# BULLETIN

## *PRODUCT SERVICES - Schaumburg*

Subject: MSR2000 and MSF5000 Ferro Resonant power supplies,  
TPN1185A, TPN1218A, TPN1184A, TPN1192A, TPN1226A, TPN1227A

# Product Services Bulletin

Figure III-1. Cradle Circuit Board Partial Diagrams

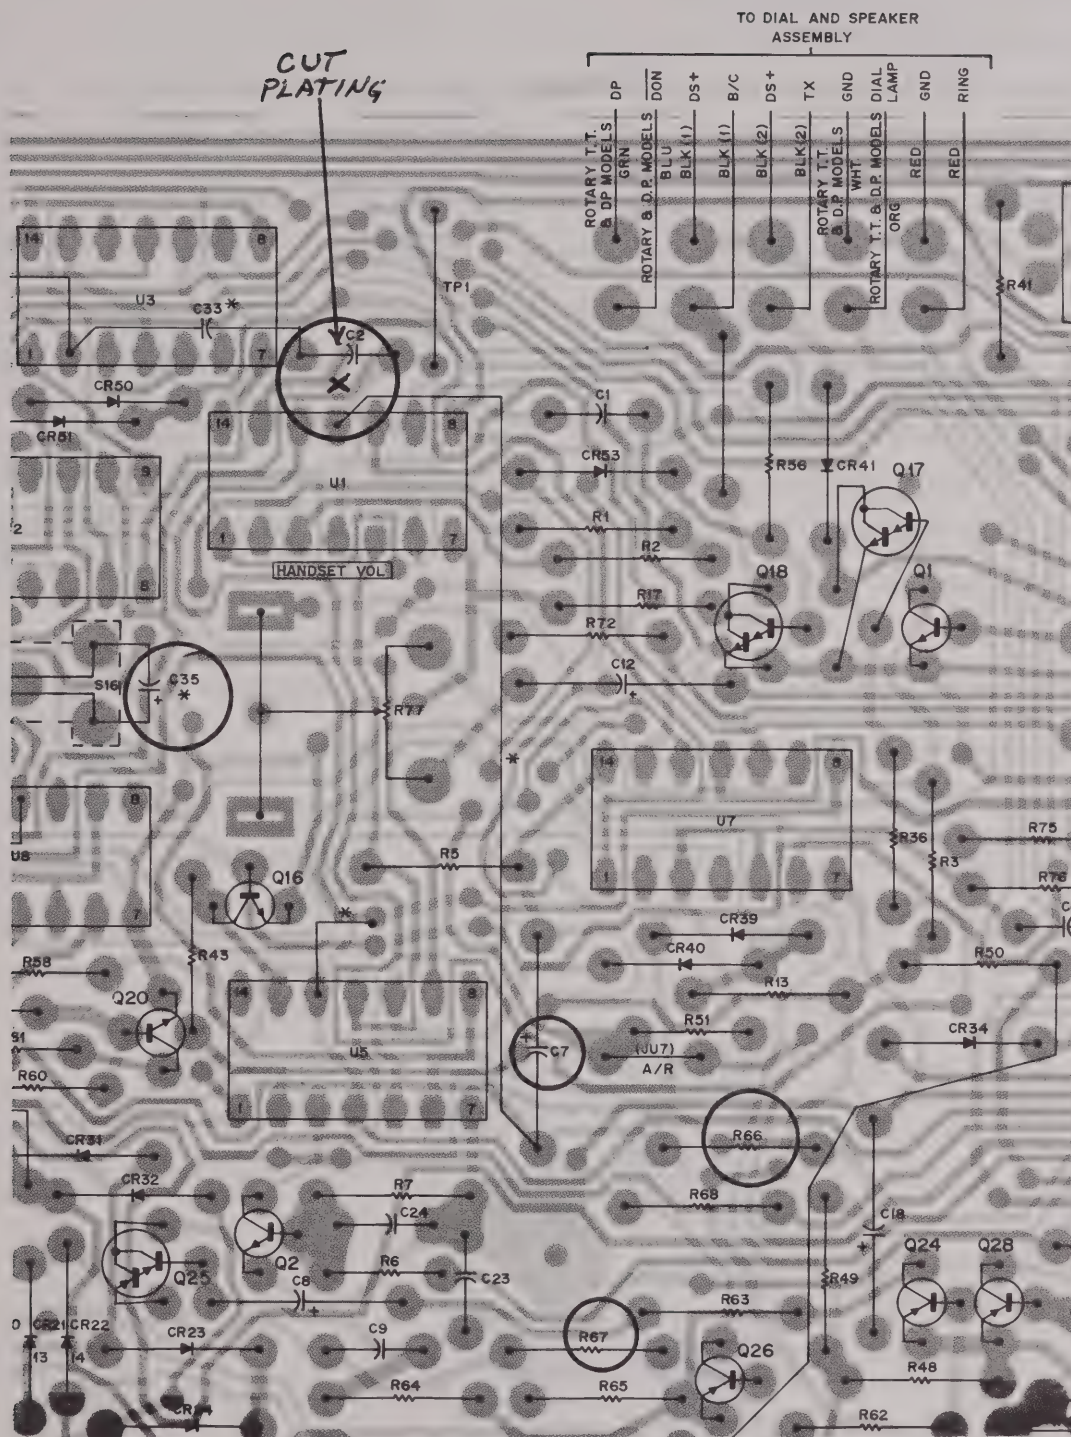
3. The modification is as follows. Refer to Figure III-1 for the recommended part placement positions and PC board runner cut. On both RCC and Telco and Bell Control Heads, add R66 and C7; refer to Figure III-1 for location. Do not solder C7 in yet as a

On RCC Control Heads, add C35, a 22 uF capacitor, across the leaf switch (hookswitch), S16, on the solder side of the cradle board. Refer to Figure III-1 for proper polarity, making sure that the positive lead of the capacitor is attached to the S16 switch lead closest to the channel switches. Also, make sure that C35 does not block the access hole to volume pot R77.

On all control heads, Telco, Bell, and RCC, the following additional circuitry change must be made. Cut the circuit board metalization runner on the component side leading from U1 pin 11, as shown in Figure III-1. Add an insulated jumper wire (eg., #24AWG, stranded) from U1 pin 11 to the negative end of C7, and complete the soldering of C7. The PC runner must be cut on the component side; the jumper can be added to the solder side.

Figure V-1. Interconnect Diagram

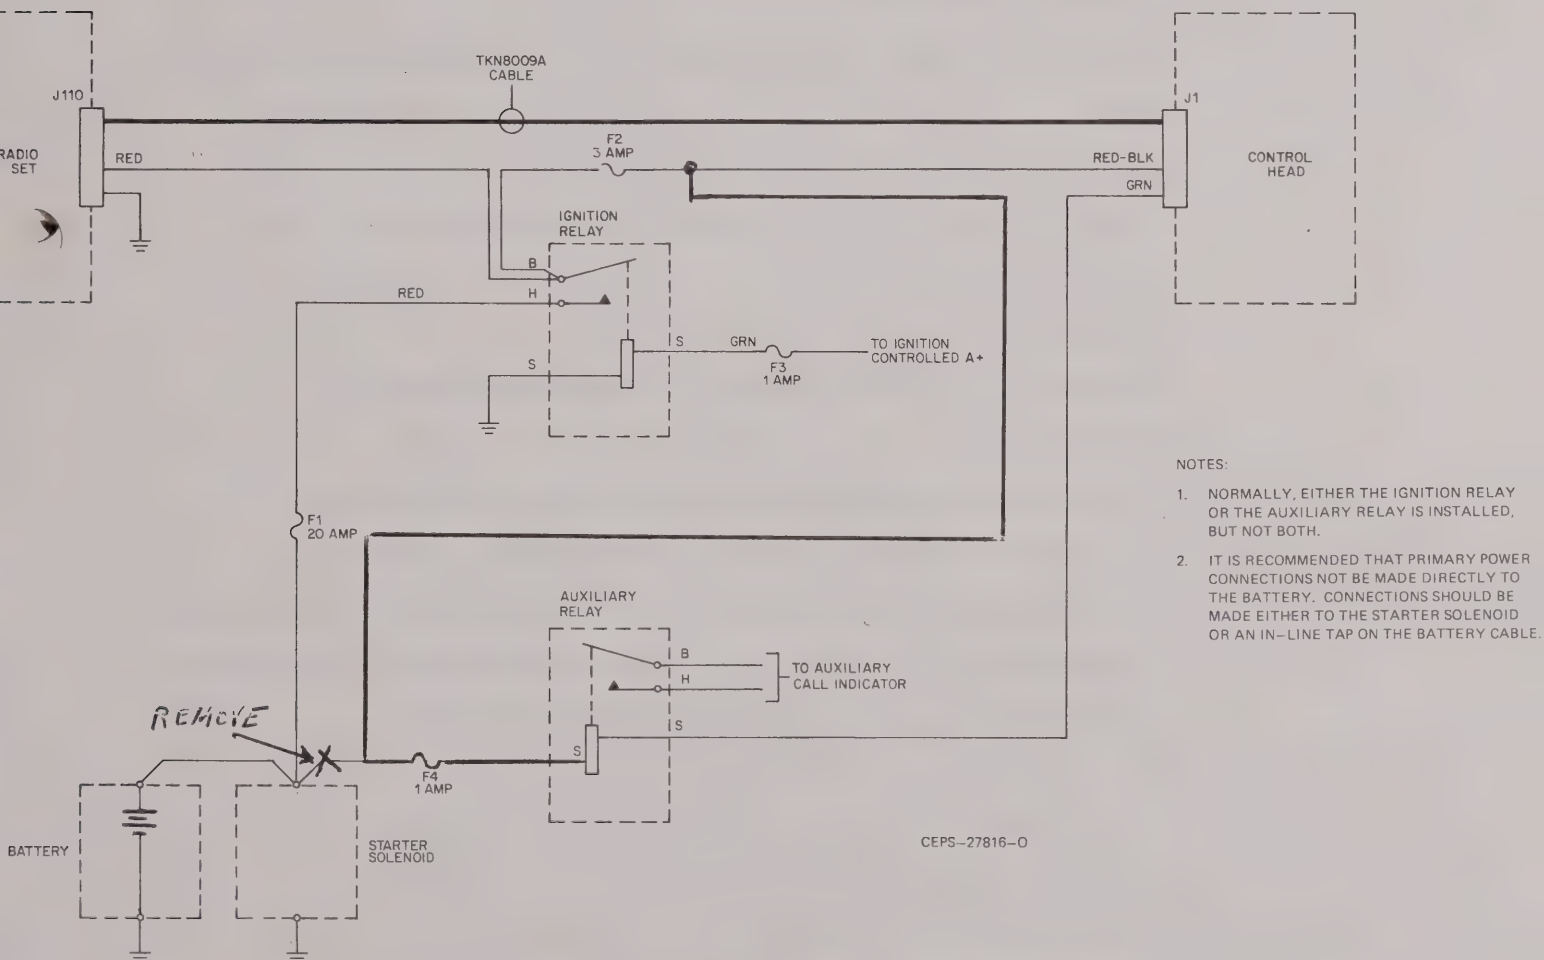
1. Connecting the Auxiliary Relay Coil directly to the battery will result in the Auxiliary Alarm being activated continuously if the Cable Kit 3 amp fuse blows open. The A+ side of the auxiliary Relay Coil should be spliced into the Cable Kit 3 amp power line on the radio side of the 3 amp fuse.
2. "PULSAR 100" service manuals, 68P81037E50 issues O, A, and B, have a diagram in the Installation section on page 9 that incorrectly shows interconnecting the Auxiliary Relay Coil. Issue C service manual shows the correct interconnect scheme.
3. Figure V-1 exhibits a corrected "Interconnect Diagram".

Figure 1. Modified TEK-27 Junction Box

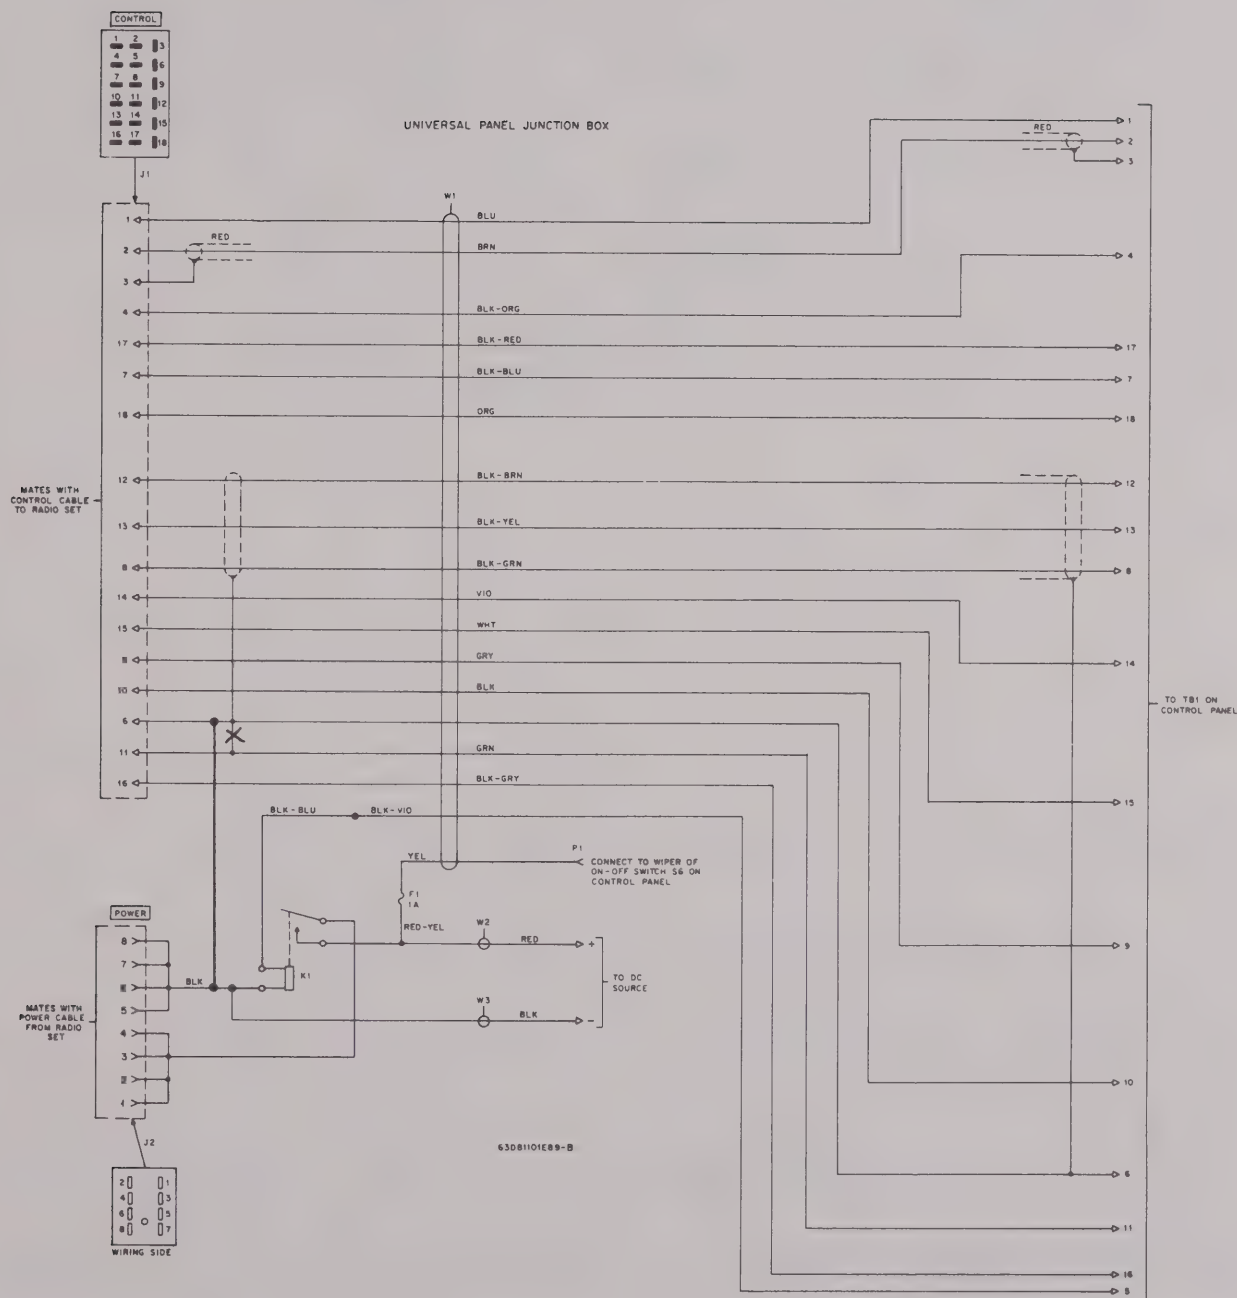
- 3.1 In the TEK-27 Junction Box, remove the BLK wire between pins 6 and 11 of J1 (Refer to Figure 1).
- 3.2 Make the following changes in the TEK-25 Universal Control Panel: (refer to Figure 2).

Figure 2. Modified TEK-25 Universal Control Panel

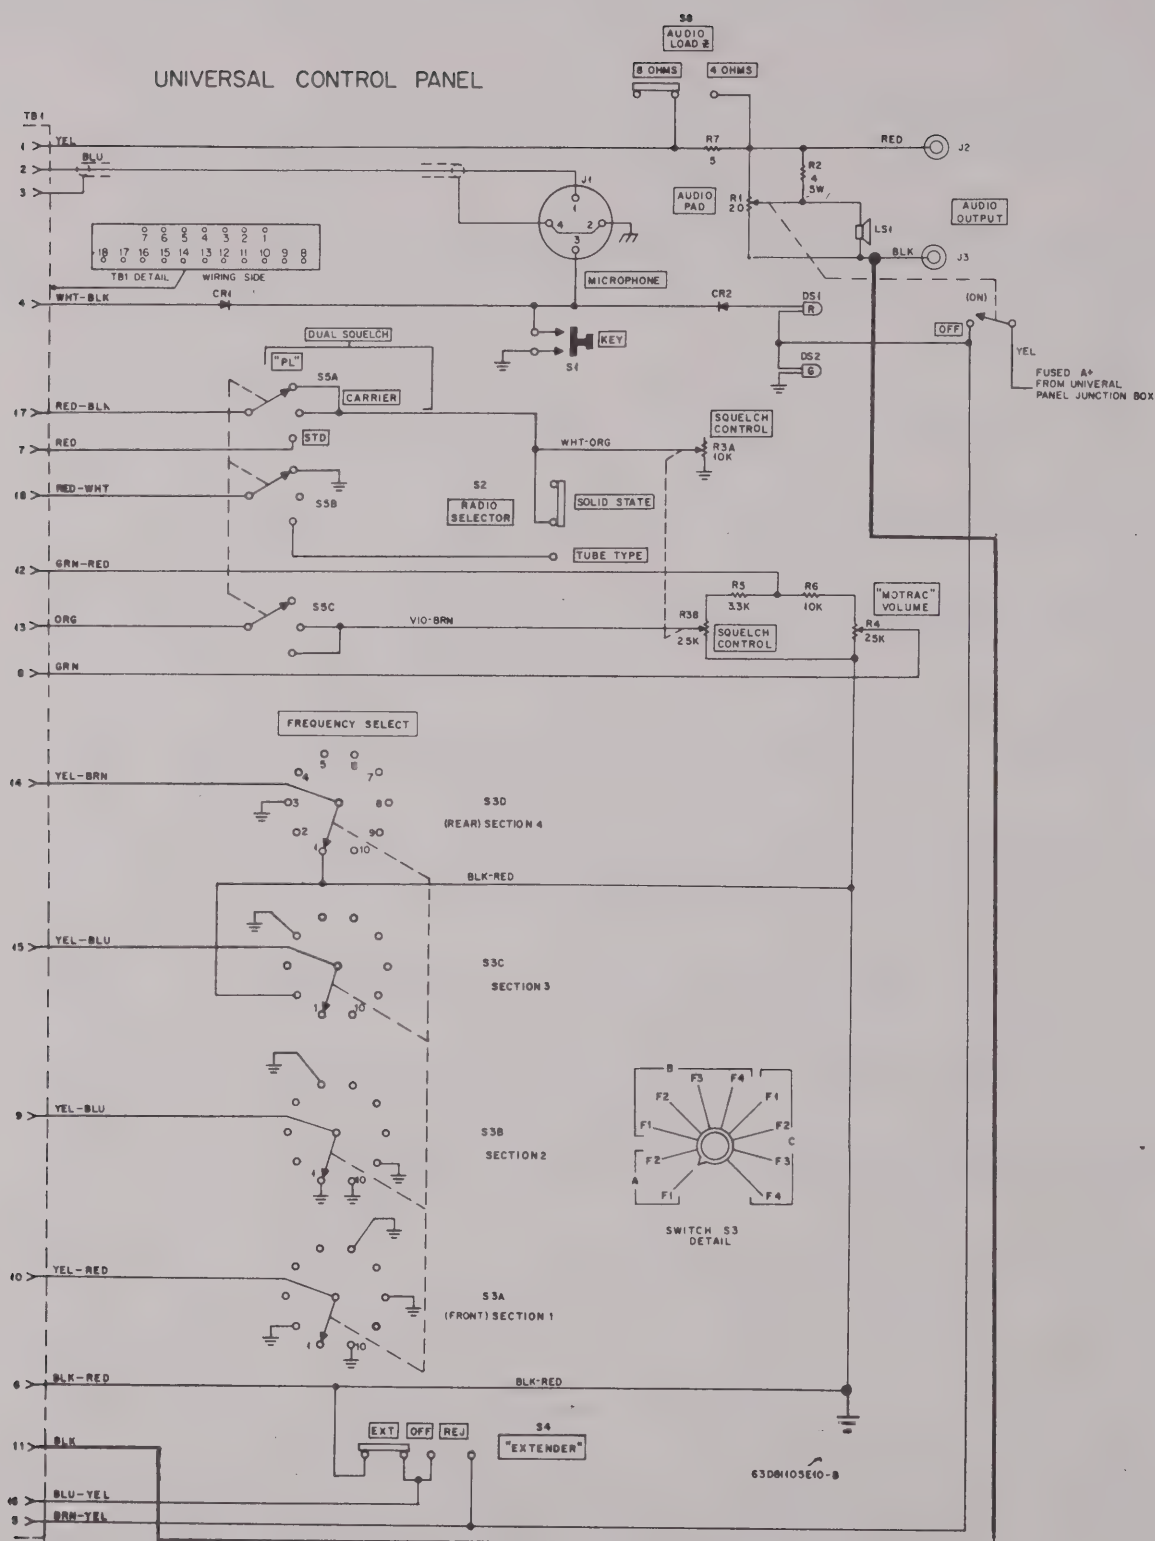
- 3.2.6 Connect a wire between the now empty speaker terminal and the end of R1 closest to TB1, where now only 1 BLK wire and R2 are connected.
  - 3.2.7 Connect a wire between this same terminal of R1 and pin 11 of TB1.

Figure 2. TRN6025A-1 Manual Control Board Partial Circuit Board Detail

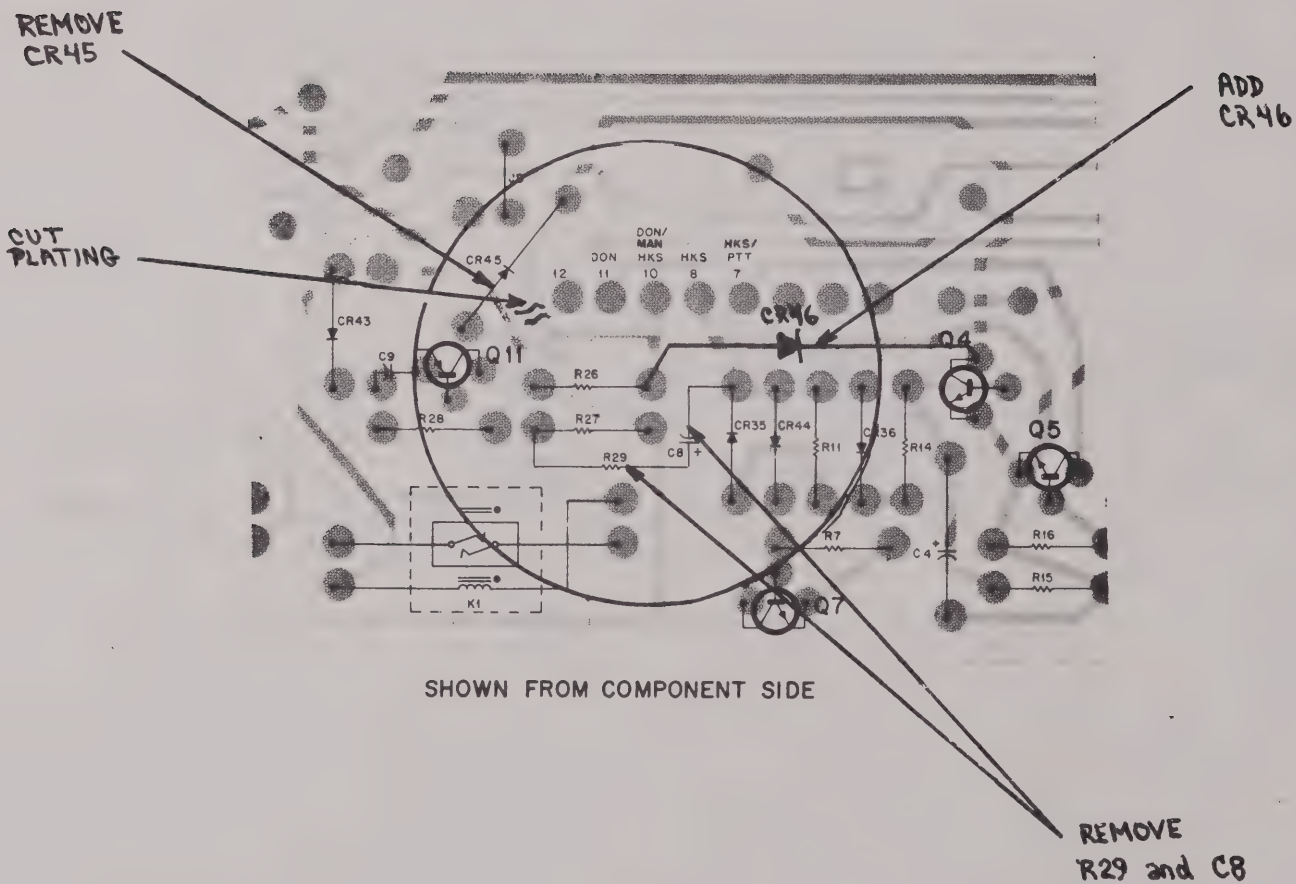
1. Remove R29, C8 and CR45 from the TRN6025A Manual Control Board.
2. Cut the PC board foil as shown in Figure 2 or Figure 3.
3. Add a silicon diode, CR46 (Pt. No. 48-83654H01 or equivalent) as shown in Figure 2 or Figure 3.

Figure 1.

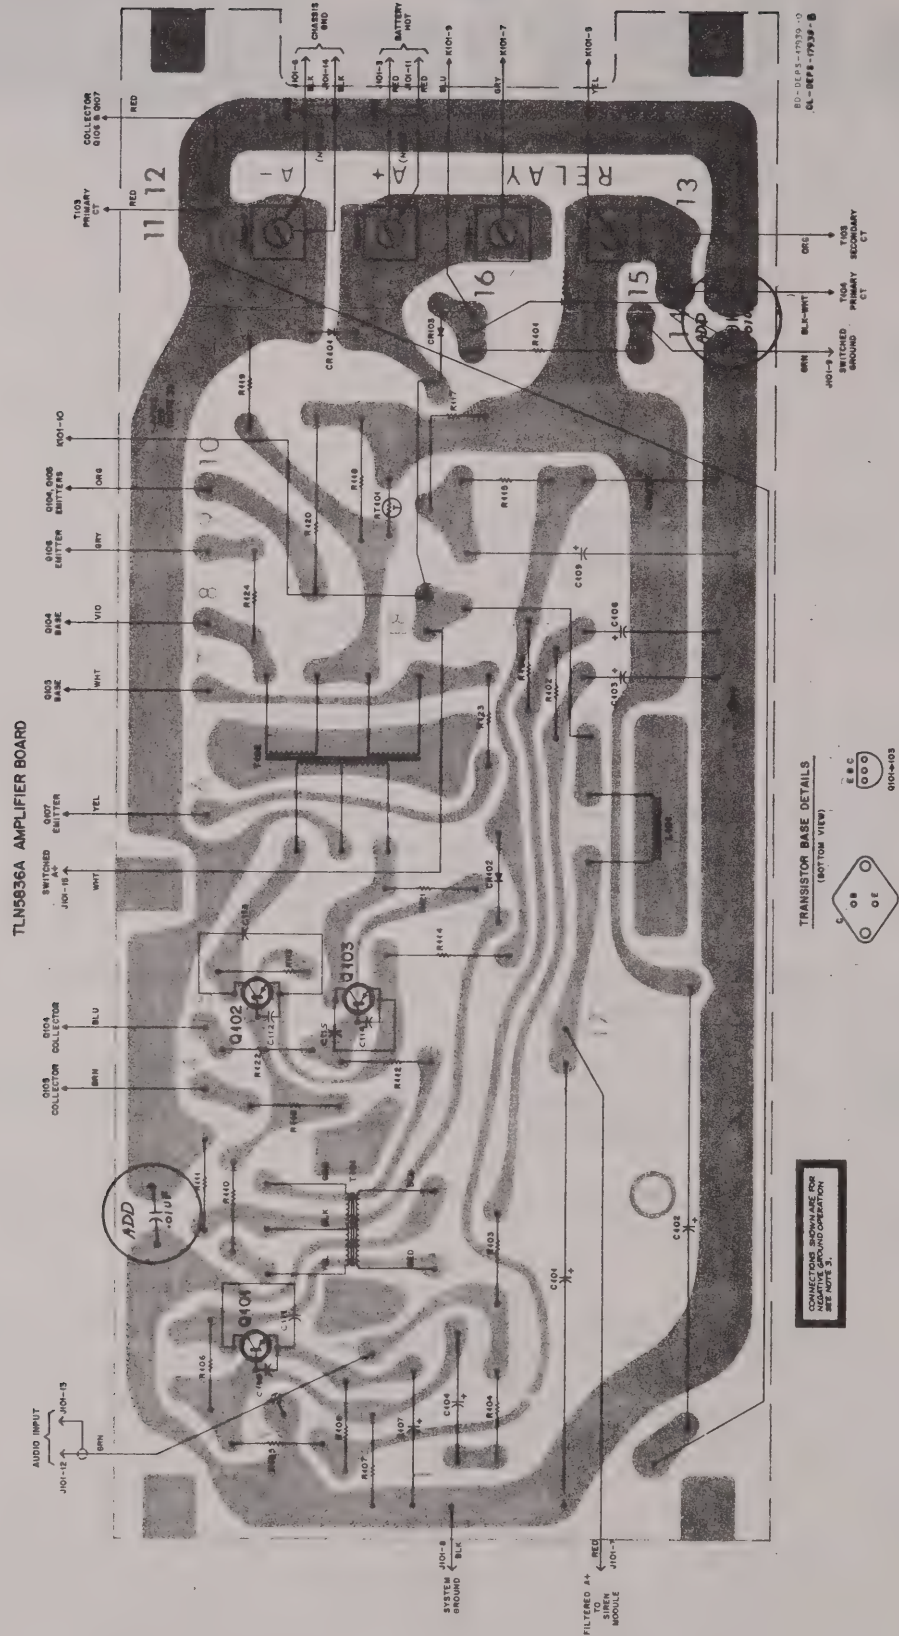
The problem can be resolved by adding two .01 uF capacitors on the "A" version of the TLN5836 siren control board (See Figure 1) or one .02 uF capacitor on the "B" version of the TLN5836 board. (See Figure 2).

Figure 3.

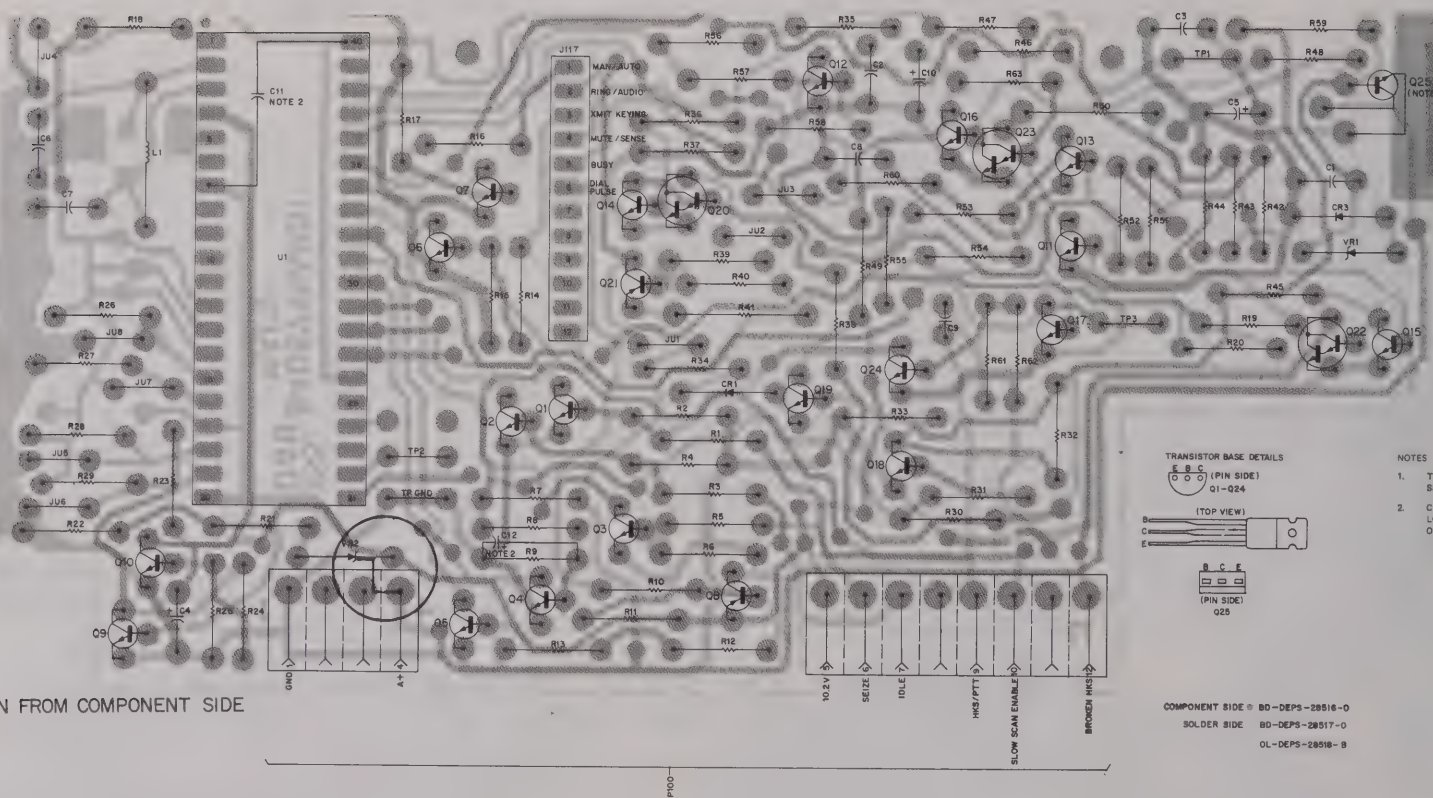
With a low battery voltage (7 volts), the main 10.2 V dc radio regulator and the MACS 5.0 V dc regulator may exist in a quasi-ON state. Voltage to the MACS circuit may drop to 2.0 V dc or less. At a supply voltage of 2.0 V dc the MACS microprocessor may ignore its reset command and activate the ringer line erroneously. The addition of a 12k resistor across the Zener reference diode VR101 in the 10.2 V dc regulator circuit (see Figures 1 and 2) will insure an orderly and predictable shutdown of this regulator under low voltage condition. This modification has been added to all radios shipped after April 6, 1981. In some extreme situations where the vehicle battery voltage drops below 4.0 volts during engine cranking, it may be necessary to reconnect the RESET line as shown in Figures 3 and 4.
